पत्रांक— २६४६ / 12-1

विषय:— जनपद— अल्मोड़ा के विधानसभा क्षेत्र जागेश्वर के अन्तर्गत लमगड़ा विकासखण्ड के ग्राम— तुलैड़ी से ग्राम पंचायत नैनी (जिफल्टा) कोकिलागांव तक मोटर मार्ग के निर्माण हेतु 3.60 है० वन भूमि का गैर वानिकी कार्य हेतु लोक निर्माण विभाग को प्रत्यावर्तन के सम्बन्ध में प्रस्ताव सं० 151058/2022।

पत्रांक 3302 /12-1 दिनांक, नैनीताल 2/5/2025.

जनपद अल्मोड़ा में तुलेशी से कोकिलगँव तक रिक मोटर मार्ग का निर्माण

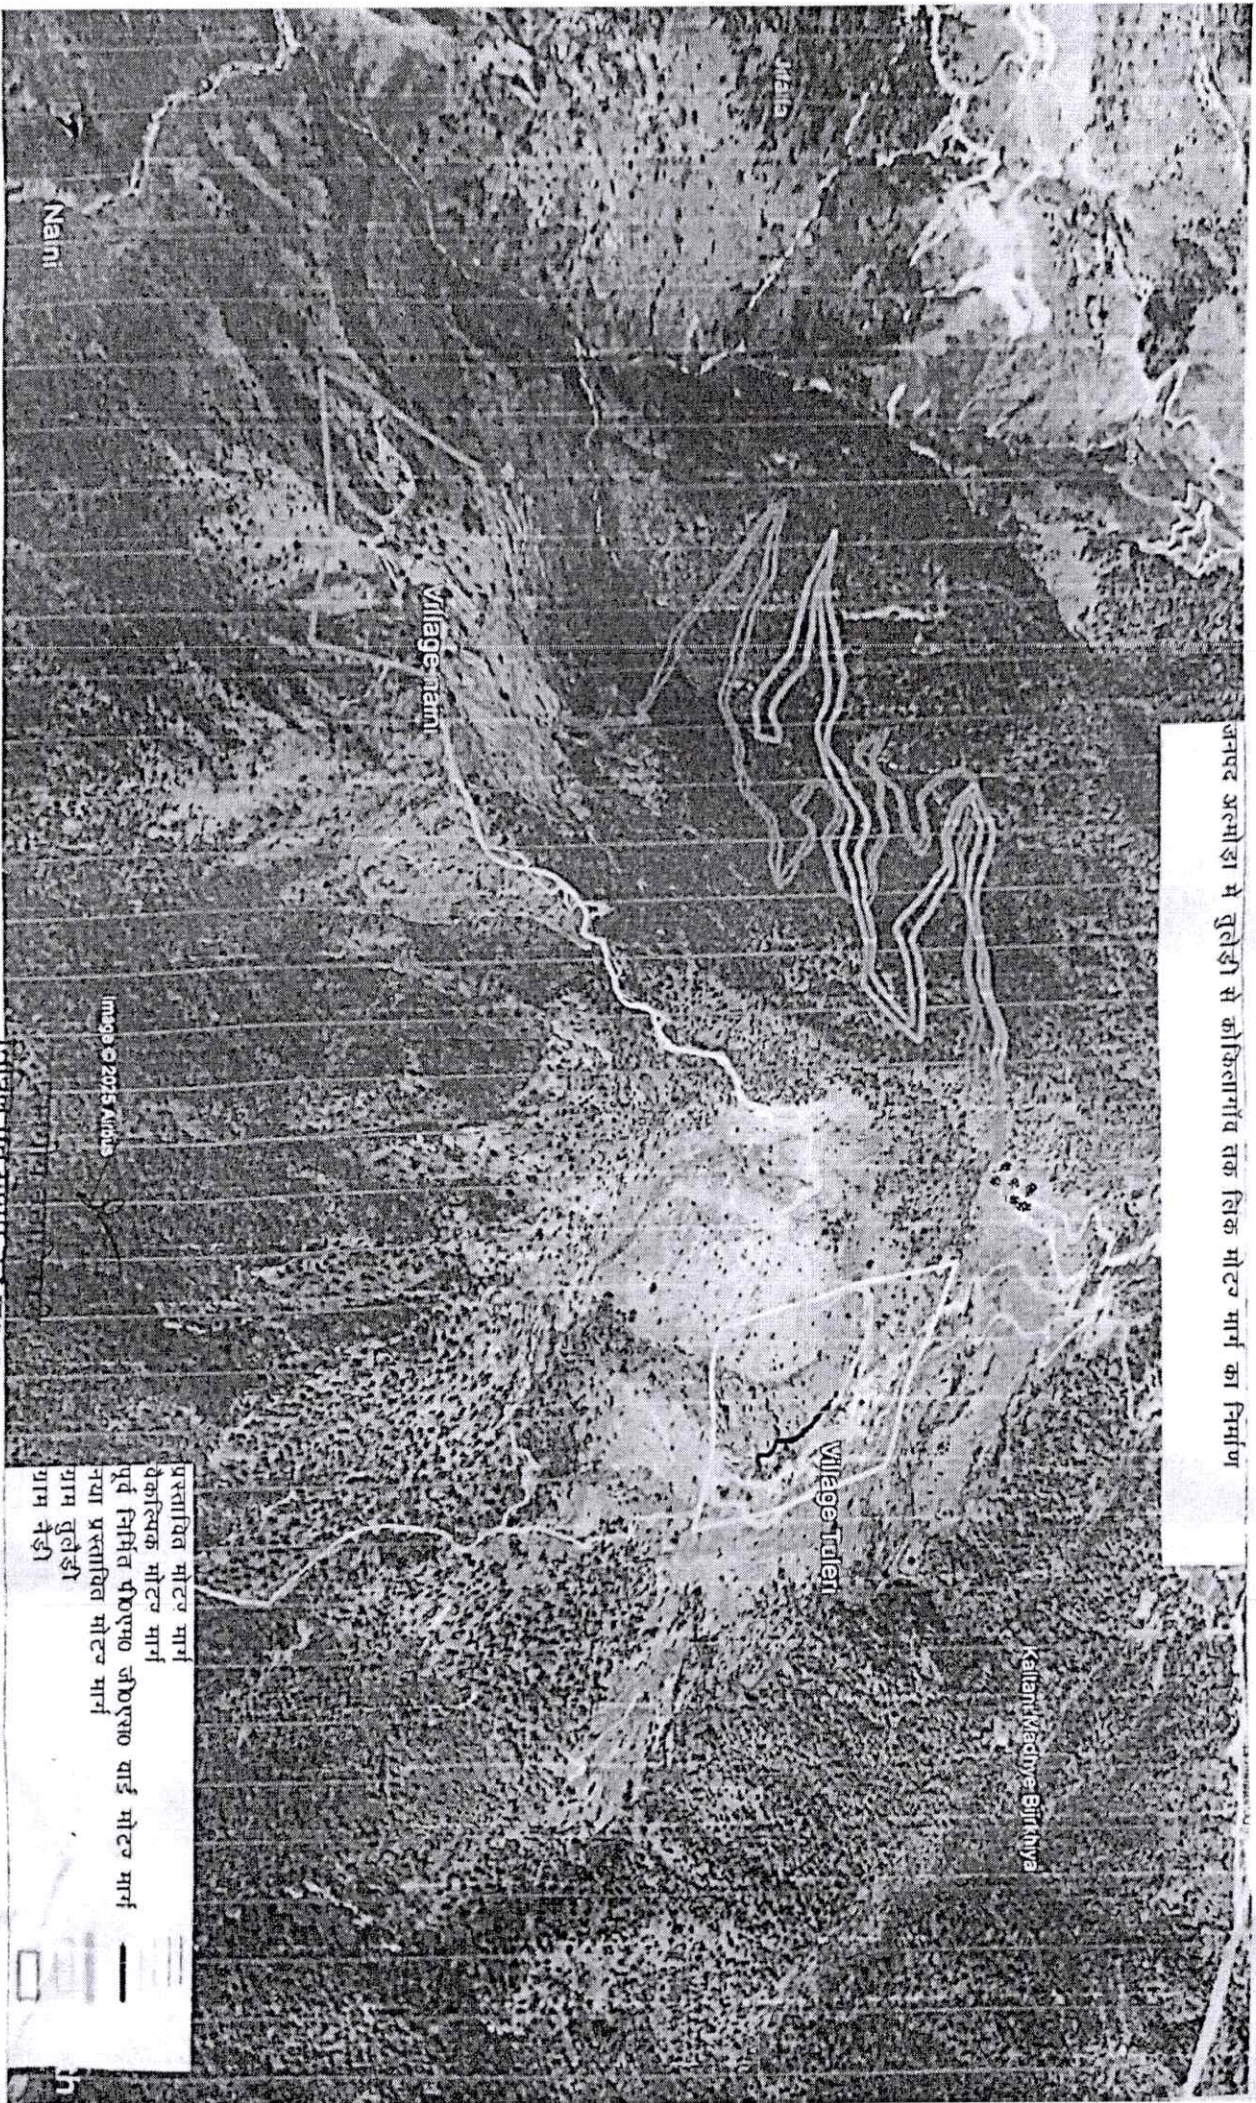
For reference, a Google Map is attached herewith, which shows an existing trek route along which the user agency can propose a new alignment.

Query	Reply
1) As per the submitted Geologist report, the road construction is not be possible in very steep slope area, so the proposal is liable to be rejected. State Government (not below the rank of CCF) shall submit detailed comments in this regards.	<p>As per Geologist report, the proposed alignment is passing through steep slope from which if road will be constructed the generated muck cannot be controlled effectively. In this respect the site was visited by DFO civil Soyam Almora on 17th of April 2025. PWD representative were also present on the site along with forest department field staff.</p> <p>After ground verification, it was amply clear that the selected site/alignment is not a fit case for road construction because of steep slope. It will also lead to ineffective muck disposal. Furthermore, the proposed construction will badly impact 4-5 small naula which join nearby river, thus affecting the sub surface and surface flow and water availability. Also, of the two villages proposed to be connected by this road, one village (Tuleri) is connected through PMGSY road.</p> <p>After perusal of KML file and ground report it is suggested that user agency must reconsider the proposed alignment. There is already a PMGSY road connecting the village Tuleri. This road can be extended to the other village(Naini). This will entail mostly gentle slope also entail felling of only few trees. For Reference, the Google map is attached herewith, there is already showing a Foot-track From which new alignment can be proposed by user agency.</p>
